1984 - 1985 Corvette: Service Bulletin: Door Ajar Switch Corrosion

Subject: Door Ajar Switch Corrosion

Source: Chevrolet Dealer Service Bulletin

Bulletin Number: 85-43, Number 8B (XII) & 10(I)

- REPLACEMENT 14087681 DOOR AJAR SWITCH
(WITH SLEEVE)

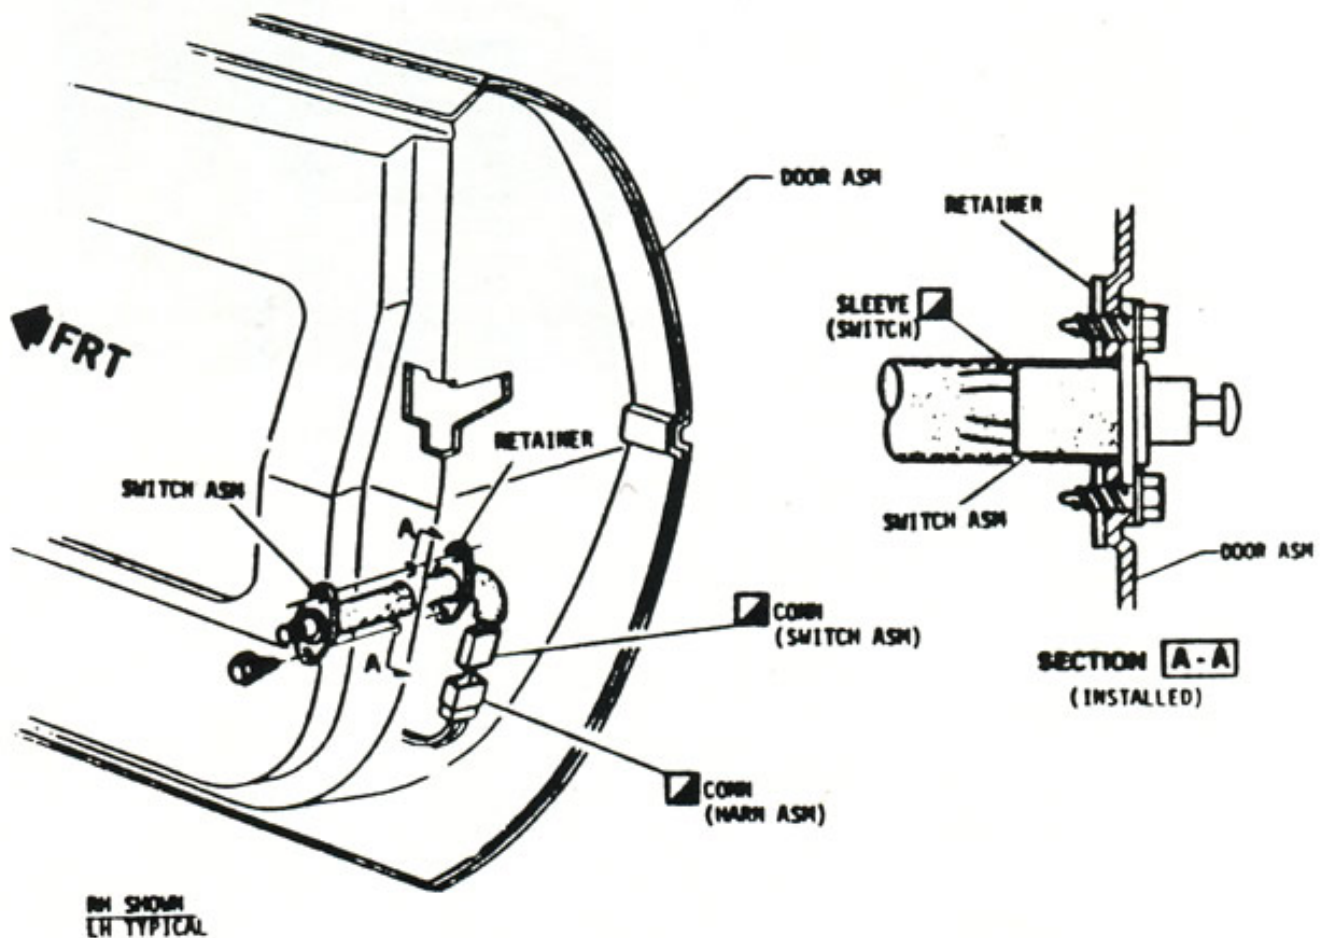
SOME 1984 AND EARLY PRODUCTION 1985 CORVETTE DOOR AJAR SWITCHES (P/N 14062556) MAY BECOME INOPERATIVE DUE TO INTERNAL CORROSION. THIS CAUSES THE DOOR AJAR LIGHT TO EITHER BECOME INOPERATIVE, FLICKER, OR STAY ON.

A NEW CORROSION RESISTANT SWITCH (P/N 14087681) AND AN ASSOCIATED RETAINER (P/N 14087682) ARE TO BE USED AS SERVICE REPLACEMENTS. THE NEW SWITCH INCLUDES A SLEEVE (SEE ILLUSTRATION) THAT FITS TIGHTLY AROUND THE SWITCH'S HOUSING AND HAS SUFFICIENT LENGTH TO COVER THE WIRE CONNECTOR ONCE CONNECTION TO THE DOOR HARNESS IS MADE.

WHEN REPLACING THE EXISTING SWITCH WITH A NEW 14087681 SWITCH, THE DOOR INSERT HOLE WILL NEED TO BE ENLARGED FROM 16MM TO 18MM TO ACCOMMODATE THE SLEEVE PROVISION. CARE MUST BE EXERCISED WHEN ENLARGING THE INSERT HOLE SO THAT ADJOINING MOUNTING HOLES ARE NOT ALTERED. SCRATCHES, CHIPS, ETC., TO DOOR PANEL SURFACE RESULTING FROM THE HOLE ENLARGING PROCESS ARE TO BE COSMETICALLY REPAIRED AS OUTLINED IN SECTION 10 (BODY) OF THE CORVETTE SHOP MANUAL.
